# UNITED STATES PATENT AND TRADEMARK OFFICE

10/711,580

<b>Office Action Summary</b>	<b>Application No.</b>	<b>Applicant(s)</b>	
	10/711,580	DUFFY, JAMES FRANCIS	
	<b>Examiner</b>	<b>Art Unit</b>	
	Brent T. O'Hern	1772

## DETAILED ACTION

FIG. 1

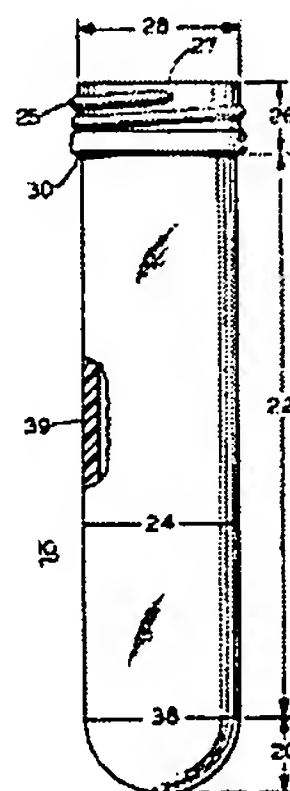
Regarding claim 1, Sincock ('120) teaches a hollow, cylindrical-shaped bottle (FIG-1, #10 and col. 5, ll. 13-42) having an open-ended mouth-forming portion (FIG-1, #26 and col. 5, ll. 24-27), an intermediate body-forming portion (FIG-1, #22 and col. 5, ll. 15-17) and a closed, hemispherical-shaped base-forming portion (FIG-1, #20 and col. 5, ll. 3-8).

Regarding claim 2, Sincock ('120) teaches a bottle wherein the body-forming portion has constant outer and constant inner diameters (*FIG-1, #10, col. 5, ll. 5-16 and col. 8, ll. 3-8*).

FIG. 5

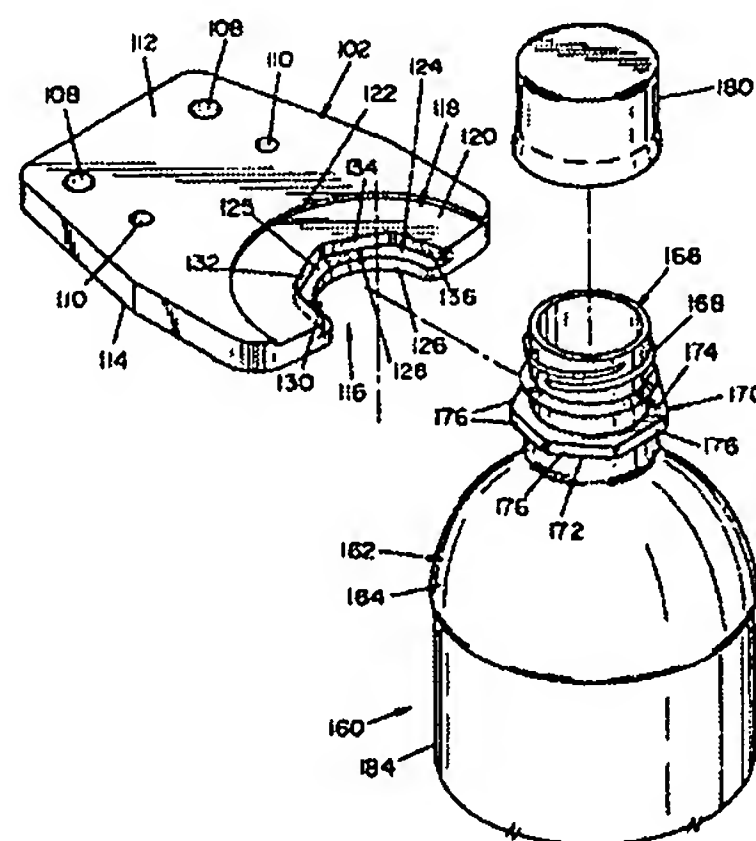
However, Peronek ('160) teaches wherein the mouth-forming portion comprises a polygonal-shaped flange perpendicular to the plane of the body-forming portion and where each isometric outside surface of the flange is substantially straight (*FIG-5, #170 and col. 16, l. 64 to col. 17, l. 8*) for the purpose of inhibiting or preventing rotation of the bottle during the capping process (*col. 18, ll. 25-37*).

Therefore, it would have been obvious to a person of ordinary skill in the art at the time applicant's invention was made to modify Sinock's ('120) bottle with the above polygonal-shaped flange as taught by Peronek ('160) in order to provide a bottle that inhibits or prevents rotation during capping.
